**January 26, 2016
Medway Planning and Economic Development Board
155 Village Street
Medway, MA 02053**

TRI VALLEY COMMONS – WINDOWS AT ADVANCE AUTO

SALMON/WILLOWS ARPUD – PUBLIC HEARING CONTINUATION:

**Tri Valley Commons – Faux Windows at
Advance Auto Building**

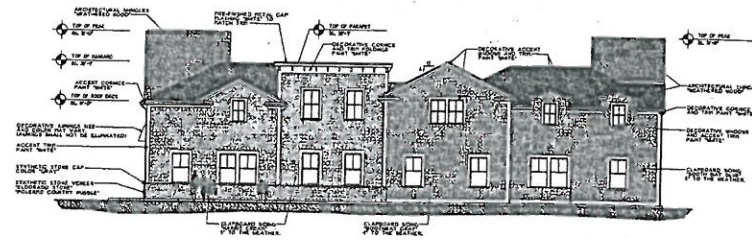
We have all seen faux windows which have glass or a reflective surface with a dark background that convey the purpose and form of a window far more completely and attractively than what is currently installed at Advance Auto. See below.

PROPOSED ELEVATIONS
 RETAIL BUILDING 'B'
 TRI VALLEY COMMONS
 MEDWAY, MA

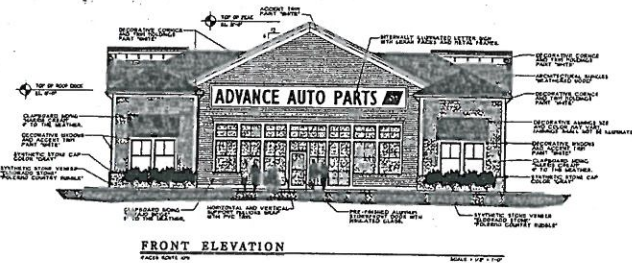
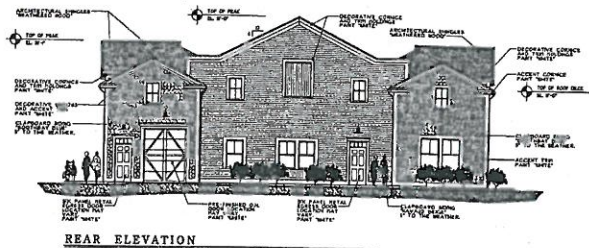
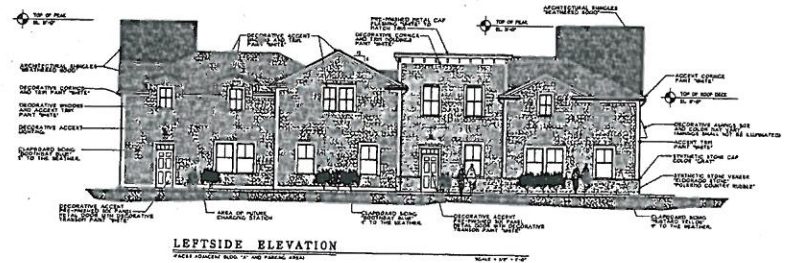
The Board discussed that the windows installed at the Advance Auto building were not what was expected. The window area and trim are covered completely in white. The drawings showed some definition and depth. The Board hopes that there is some way both parties can come to a middle ground. Rich Landry has requested meeting copies of the minutes and audio recordings for when the Board and the DRC reviewed this project. He did email the Town Administrator about this issue. The date of the endorsed plans was July 14, 2015. The plans from July 10, 2015 show real windows on the first floor and fake windows on the second floor. The definition of the windows was noted. There was a second approval under a modification from the September 8, 2015 meeting. It was suggested that those plans be reviewed.

At the next PEDB meeting on Tuesday, January 26th, the Planning and Economic Development Board will discuss the decorative "windows" which have been constructed at the Advance Auto building at Tri Valley Commons. Members of the PEDB and DRC have received questions and complaints from the community and are concerned about the use of painted white boards masquerading as "windows" and how fake they look.

We have reviewed the approved elevation plans for the Advance Auto building (Sheet A 2.2). The plan notes state "Decorative Windows with Accent Trim White". The plans show definition and depth to the windows. We all understood that the windows would not open and close nor would they serve as product display windows. However, we believed that they would look like actual windows even if frosted or opaque. We did not expect them to look as phony as they do. The current appearance of the windows is not what anyone had anticipated. A white painted board cannot be interpreted as a window. They actually look as though they are boarded up! This is not acceptable and needs to be remedied.

Please find a solution for a replacement window surface that is more glass-like in appearance and provide this information to us before next Tuesday's PEDB meeting.

CONSTRUCTION SEQUENCING PLAN

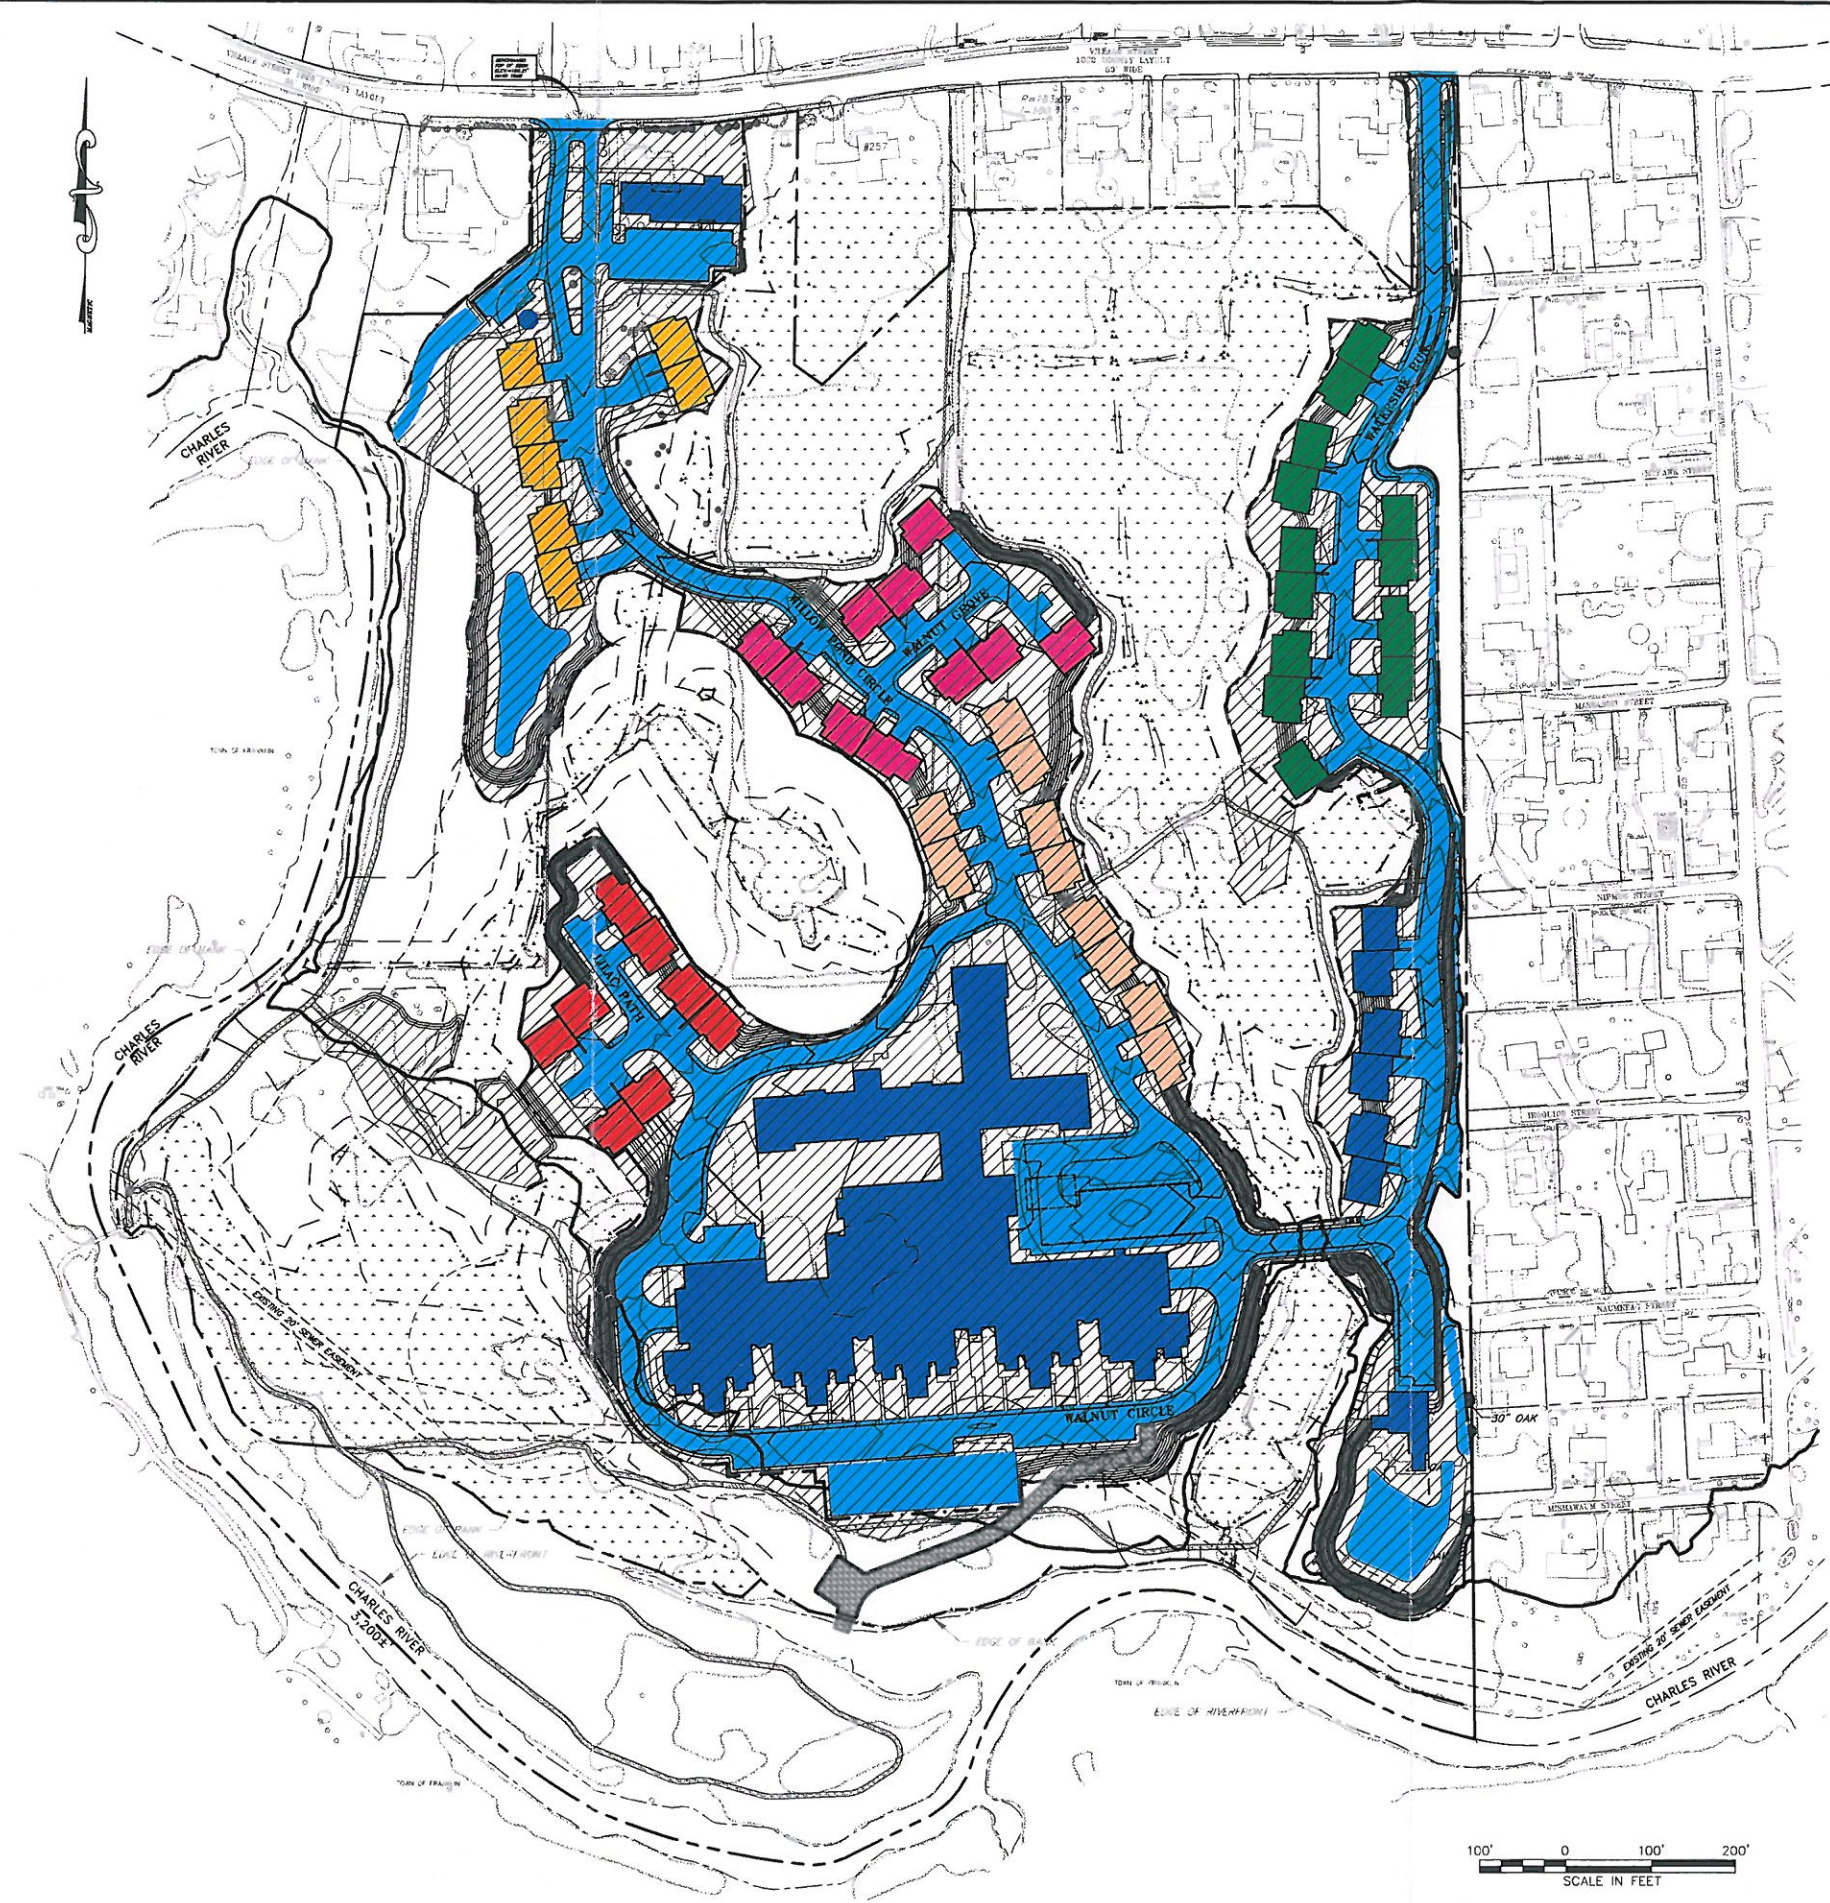
The project’s proposed construction sequencing plan was entered into the record. **(See Attached)**. It show the seven phases. The first phase would be completed in 1-20 months including the main buildings and the medical office and few cottages.

Resident Tim Choate asked how the developer will deal with construction for the next year and a half. What happens if the developer cannot meet their goals? What will the financial and land implications be for build out?

The applicant responded that they do not want standing buildings.
